**Planning Commission
Staff Report**

October 10, 2012
Item 6.a.

- SUBJECT:** PUD- 88
- APPLICANTS/
PROPERTY OWNERS:** Sherman D. and Cheryl Balch
- PURPOSE:** Application for Planned Unit Development (PUD) development plan approval to subdivide an approximately 10-acre lot into two single-family residential lots: (1) an approximately 3.5-acre parcel containing the existing residence, detached garage, and sport court; and (2) an approximately 6.5-acre lot which would include the construction of an approximately 4,000-square-foot single-story home and attached garage, a 1,200-square-foot detached second, and two detached garages.

- ZONING:** Unincorporated (Prezoned: Planned Unit Development - Semi-Rural Density Residential and Agricultural/Open Space)
- LOCATION:** 6010 Alisal Road

Figure 2.2: Proposed Site Plan Overlaid With the UGB and SSZ Notations

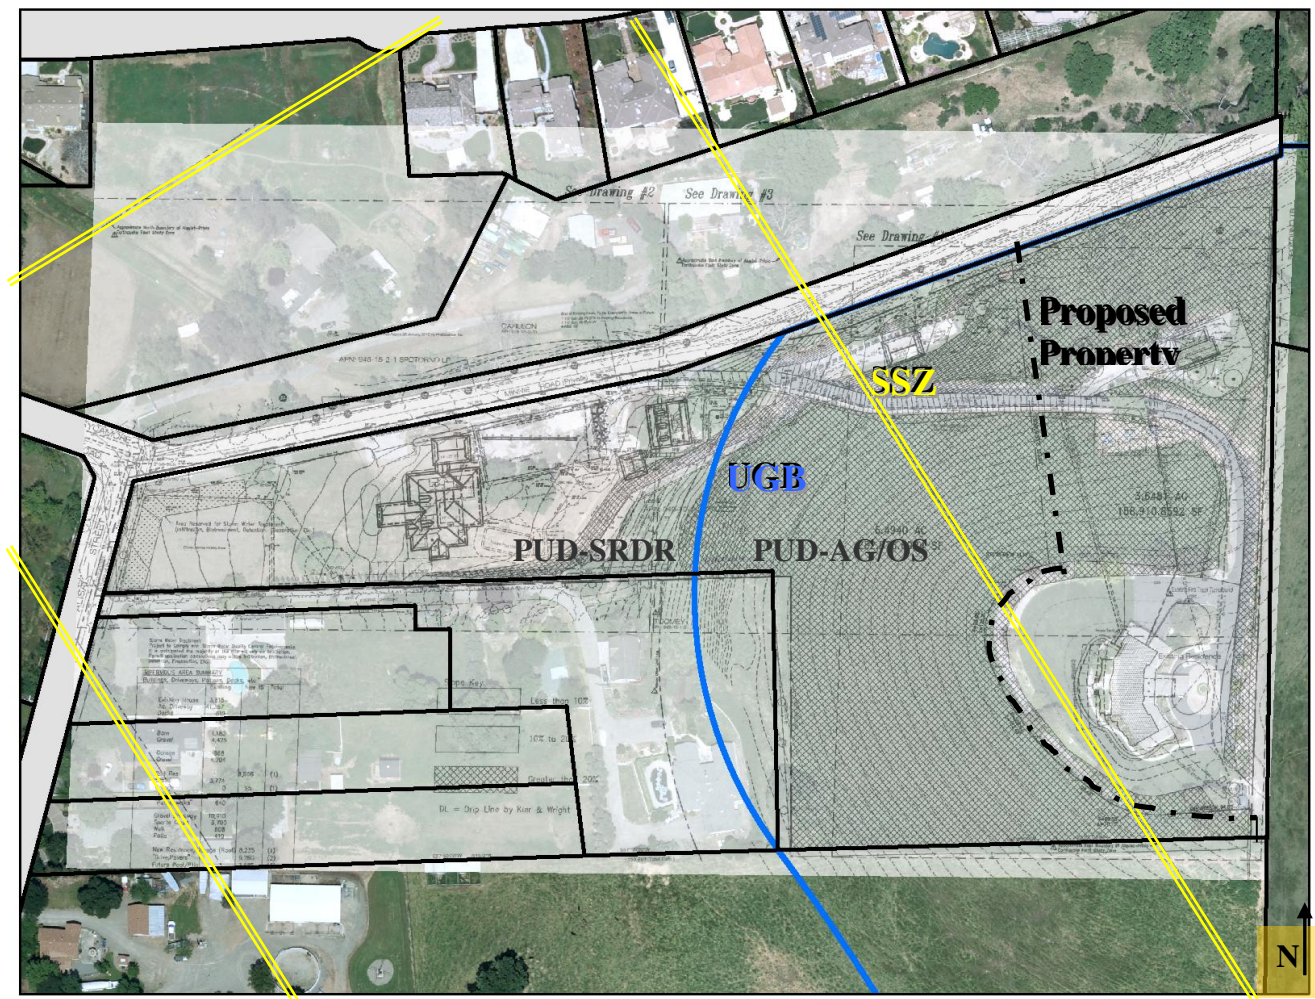
Staff believes that the proposed project is consistent with the General Plan based on the development of the new residence occurring within the Urban Growth Boundary; the new garage structure that is being proposed outside of the UGB is considered by staff to be a non-urban type of structure and is therefore allowed to occur outside of the UGB. The extension of City services beyond the boundary would be to provide services to the existing home and is consistent with similar approvals where providing such services was considered as a public health and safety overriding consideration.

Figure 4.1: Development Plan with Structure References

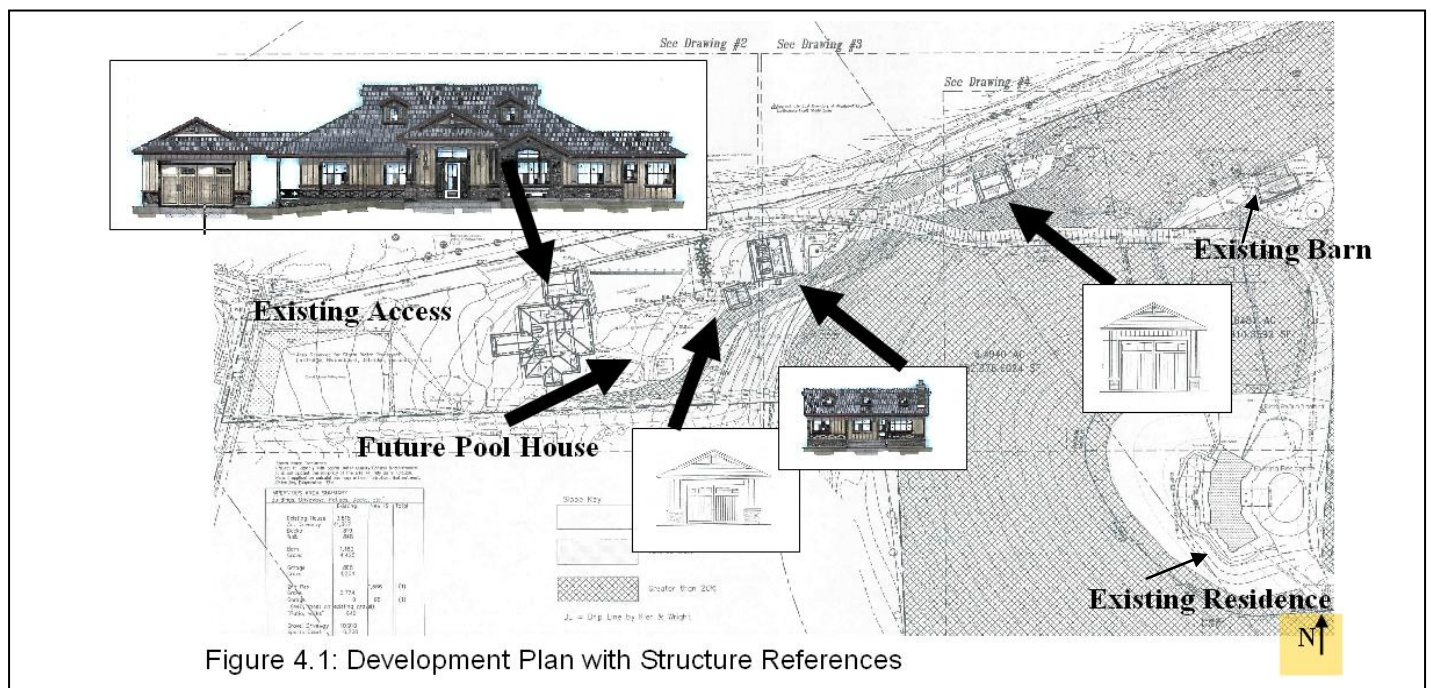
The new lot being created at the front of the parcel would retain the existing corrals, 5,000 gallon water tank, well, and sports court and would be adding several new structures. The new development on the front lot includes a new main residence with an attached garage, a new detached second unit with its own detached garage, and an additional detached garage located toward the rear of the new lot. The site plan also indicates the location of a future pool

and pool house, which are not part of this approval. The establishment of an access easement will maintain the current method of access to structures. The Fire Department has reviewed the access and driveway and determined they are adequate for providing emergency response.

Staff supports the creation of a lot that does not contain street frontage given the existing development pattern of the existing structures at the rear of the parcel with access provided by an existing long private driveway.

Figure 4.3: Front Parcel- Main Residence and attached garage (front elevation)

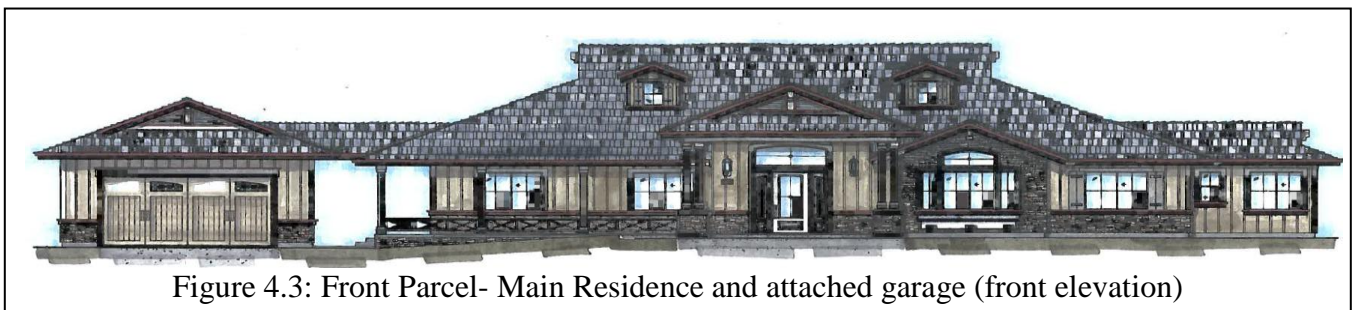
The proposed architecture for the development has incorporated ranch style architecture materials that are appropriate for a rural setting and porches. All of the proposed structures are single-story, with the garage either set-back from the face of the residence or located behind other structures and the carriage style garage doors help mitigate any visual impact that may occur, and the house entries are proportionately sized for each structure.

Therefore, staff believes that the design elements for the proposed development meet the standards of the HVSP for architecture within the PUD-SRDR District.

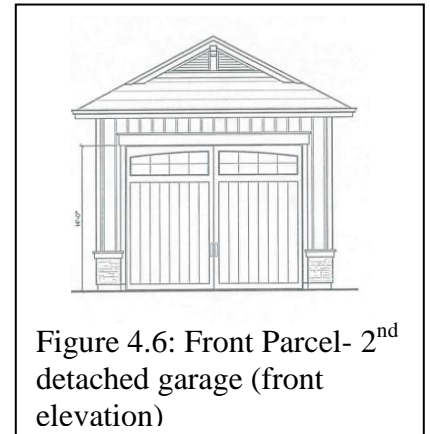
The proposed architecture for the garage has incorporated ranch style architecture materials that are appropriate for a rural setting. The applicants have indicated that the third garage is for storage of agricultural equipment, which requires a slightly taller structure (18 feet, 6-inches tall) than a typical residential garage (15 to 17 feet tall). However, the design echoes the same elements, materials, and detailing as the other proposed garages. See Figure 4.6.
